Stair flip study · the main stair turned round: start and arrival at the NORTH end, next to the lift · Taif / Palm House V8.0 (work) · STUDY ONLY

ADOPTED 2 Nov 2026 (owner): option B, the freed landing as F-b, the balustrade, the store door onto the riwaq, the half-landing window, the entrance side light, the entry cupboard removed; applied to the design files. Owner's idea, 1 Nov 2026 · the same well (2.75 × 5.7 on axes, 2.525 × 5.50 clear), the same 22 risers × 0.164 / goings 0.28, flights 1.21 clear · nothing in the design files changes until the owner decides · all sizes assumed

1 · The two options on the ground floor

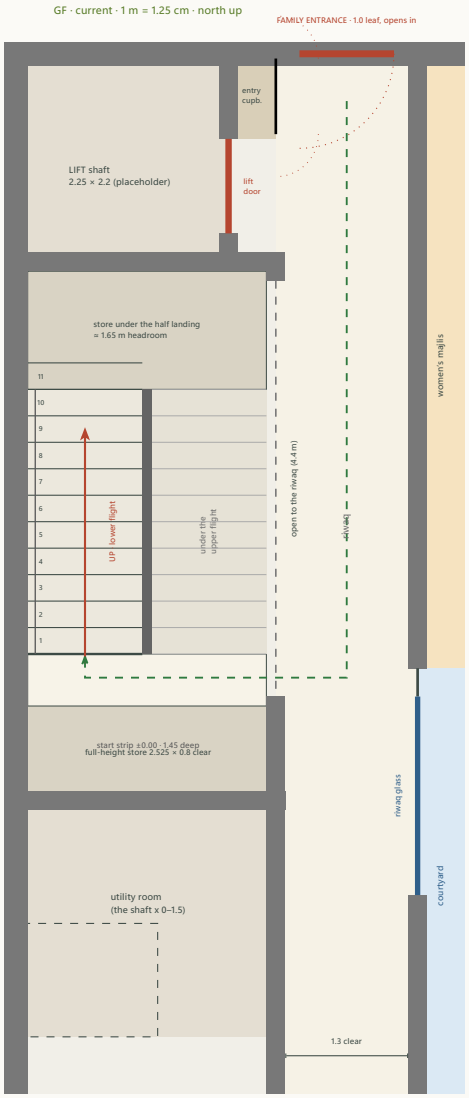
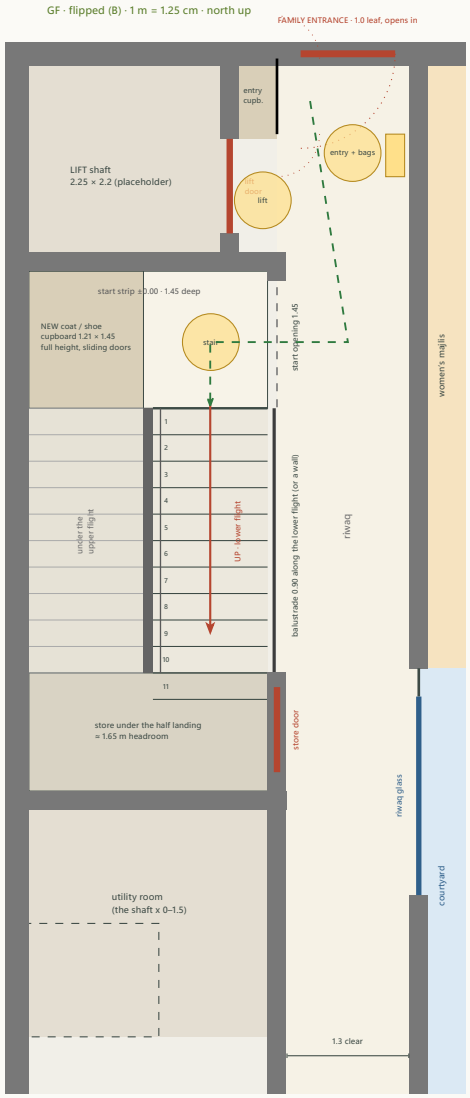
- **Current:** the lower flight on the **west** half starts at the **south** end (first riser y 6.35); the person comes along the riwaq, enters the well through its open east side (4.4 m open) and turns west onto the flight; in front of the first riser only **0.55 m** before the full-height store's wall (the start is really made from the side, under the upper flight's high end). Half landing at the north end (+1.80, a 1.65 m store below it, opening east onto the riwaq); the full-height store 2.525 × 0.8 clear at the south end.

- **Flipped (B, recommended of the two flips):** the lower flight on the **east** half starts at the **north** end (first riser y 3.75), **straight off the lobby**: a 1.45 m opening in the x 2.75 line between the lift notch and the flight, a start strip 1.45 m deep in front of the first riser. The lower flight rises along the riwaq side (a 0.90 balustrade on the riwaq, or a wall: the owner's choice); the half landing at the south end with its 1.65 m store (door onto the riwaq at y 6.7–7.6, in front of the courtyard glass; or into the utility room). The **west half of the start strip** (1.21 × 1.45, full height) becomes a **coat / shoe cupboard** beside the family entrance (sliding doors onto the strip).

- **Flipped (A):** the mirror image only (the lower flight stays west): the person crosses the whole strip to the far half before climbing; no cupboard. Not recommended; everything else below holds for both.

2 · Congestion test at the flipped start (drawn)

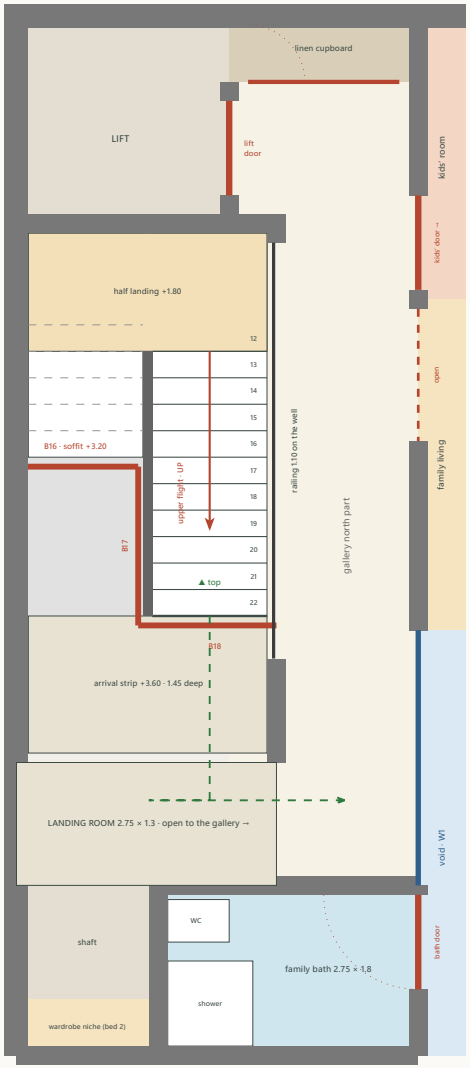
Three people at once: **one waiting for the lift** in the 0.50 m notch in front of its sliding door, **one coming in with bags** inside the family entrance's 1.0 m swing, **one starting up the stair** on the start strip, with the **entry cupboard's two 0.45 leaves open** into the lobby. Clear widths, not axes: the lobby **1.3 m** between the lift / cupboard wall face and the women's majlis wall face (the notch adds 0.5 m at y 0.9–2.2); the start opening **1.45 m**; the first riser **1.21 m** wide; the entrance **0.9 m** clear. The three stand in three separate zones along the lobby (y 0–1.0 the door swing, y 0.9–2.2 the lift notch, y 2.3–3.75 the start strip); the stair starter passes 0.3 m south of the lift waiter and never crosses the entrance swing: **OK**. Two people can pass in the 1.30 m lobby (0.60 + 0.60 + 0.10) but a person with two bags blocks it for a moment, as today. **Furniture up the stair:** the 90° turn from the 1.30 lobby through the 1.45 opening onto the 1.21 flight is a tight but normal house stair turn; the current start (0.55 m strip, sideways) is worse.

FF · current · 1 m = 1.25 cm · white = opening · grey = slab

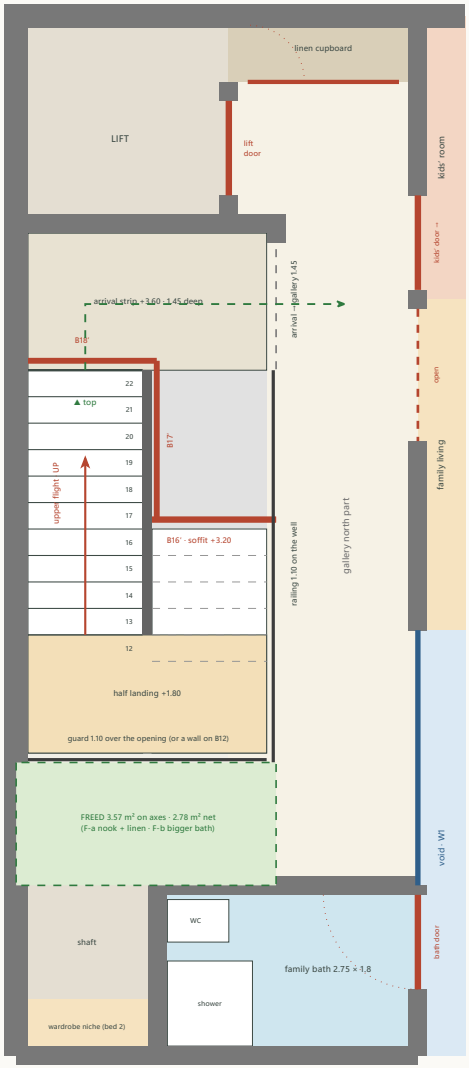
- **Current:** the upper flight (east half) lands at +3.60 on the arrival strip (y 6.35–7.8), then the **landing room** (2.75 × 1.3, y 7.9–9.2) and east into the gallery; the bedrooms and the family bath are at hand, the kids' room, the living and the lift are 6–9 m north along the gallery.

- **Flipped (B):** the upper flight (west half) lands on the arrival strip at the **north** end (y 2.3–3.75); the strip opens east onto the gallery's north part (1.45 m), **0.10 m south of the lift notch**: the lift's first-floor door, the linen cupboard (its leaves swing south, 0.6 m), the kids' room door (opens into the room) and the family living's opening are all within 1–3 m. The gallery's north part (1.30 clear) carries the arrival traffic as it carries the lift's today; the linen leaves and the lift door are 1.0 m north of the arrival: no clash. The railing on the well runs from the arrival (y 3.75) to the south wall; the landing room is **freed** (§ 5).

- **Current (studies/structure.typ):** an L-shaped opening ≈ 8.2 m²: the west half open from the north wall to B16 (y 4.85), the east half open to B18 (y 6.45); B16 (0.20 × 0.40, soffit +3.20) from the west wall to B17; B17 (x 1.29, on the lower flight's side of the split) from B16 to B18; B18 (y 6.45) from B17 to the riwaq-line beam B10 (x 2.75).

- **Flipped (B):** the **same opening turned round** (≈ 8.2 m²): the east half open from B16′ (y 5.33) to the south wall, the west half from B18′ (y 3.65) to the south wall. **B16′** (y 5.33) from the riwaq-line beam B10 to B17′; **B17′** (x 1.49, on the east, lower flight's side of the split: never over the upper flight) from B16′ to B18′; **B18′** (y 3.65, the arrival edge) from the west wall to B17′. The same zigzag, mirrored: one beam-on-beam junction at each end of B17′, the torsion the engineer's; B18′ now bears on the west wall (as B16 does today) and B16′ on B10 (as B18 does today). **Neither better nor worse** for the structure: the spans (1.3–1.6 m) and the bearings are the same kind. **Not verified.**

- **Slab edges:** the arrival strip (1.45 × 2.525) spans between the north wall beam B11 (y 2.2) and B18′; over the lower flight's first six treads the slab spans from B18′ to B16′ (1.6 m) between B10 and B17′. The guard round the opening: the railing on x 2.75 from the arrival south to y 7.9, the well's south wall line y 7.9 (a 1.10 guard or a wall on B12), the upper flight's balustrade on the split.

current · section along the lower flight, looking east · 1 m = 1 cm

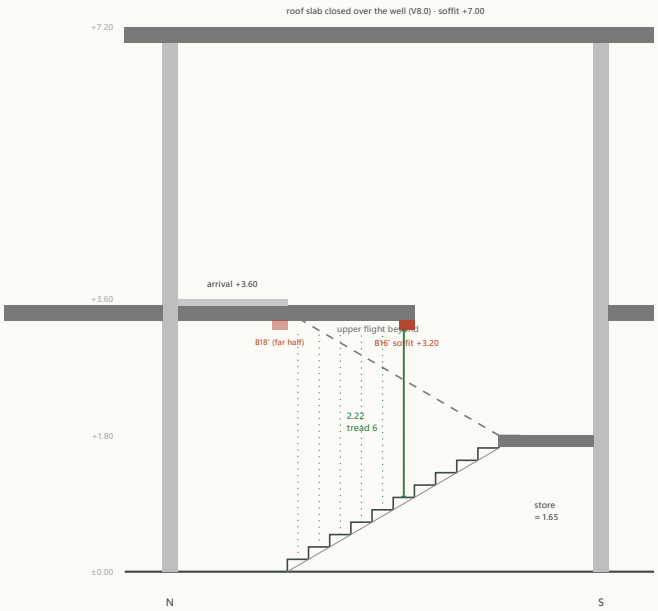
The upper flight, the half landing and the arrival are under the open well (the roof slab's soffit +7.00): ≥ 3.4 m. Minimum of this option: **2.22 m** at tread 6 under the trimmer, across the whole 1.21 m width (the trimmer spans the half); B17 over the inner 0.10 strip of treads 1–5: ≥ 2.38 m.

The upper flight, the half landing and the arrival are under the open well (the roof slab's soffit +7.00): ≥ 3.4 m. Minimum of this option: **2.22 m** at tread 6 under the trimmer, across the whole 1.21 m width (the trimmer spans the half); B17′ over the inner 0.10 strip of treads 1–5: ≥ 2.38 m.

Verdict on the headroom: identical in both options (**2.22 m** at tread 6 under the trimmer, 2.83 m at tread 3 under the slab; ≥ 2.10 required, the 2.20 aim just met) because the flip mirrors the geometry: the trimmers sit in the same places relative to the treads. **The flip neither improves nor worsens the trimmers.** What would improve both: trimmers 0.20 × **0.30** (soffit +3.30 → **2.32 m** at tread 6) if the engineer accepts a 0.30 depth for the 1.3–1.6 m spans, or the slab edge moved one tread (the opening 0.28 m longer, ≈ 0.35 m² more void, tread 6 under open sky → the minimum moves to tread 5: 2.38 m). Both options can take either. The walls' handrails run the full flights (0.08 off the walls); the central handrail on the 0.10 split.

- **Conditions:** (1) a glazed panel / side light in the family entrance (or a lobby window) and a **west window at the half landing** so the start and the well are not dark; (2) the **balustrade** along the lower flight on the riwaq side, 0.90 m, black steel in the design language (not a wall), so the riwaq keeps its width of view; (3) the freed landing as **F-b, the two-compartment family bath** (the WC by the shaft, a second basin), or F-a if the owner prefers a nook; (4) the half-landing store's door onto the riwaq (household) — or into the utility room (service), the owner's choice; (5) the headroom improvement, open to both: ask the engineer for **0.30 trimmers** (2.32 m at tread 6) before the slab is detailed.
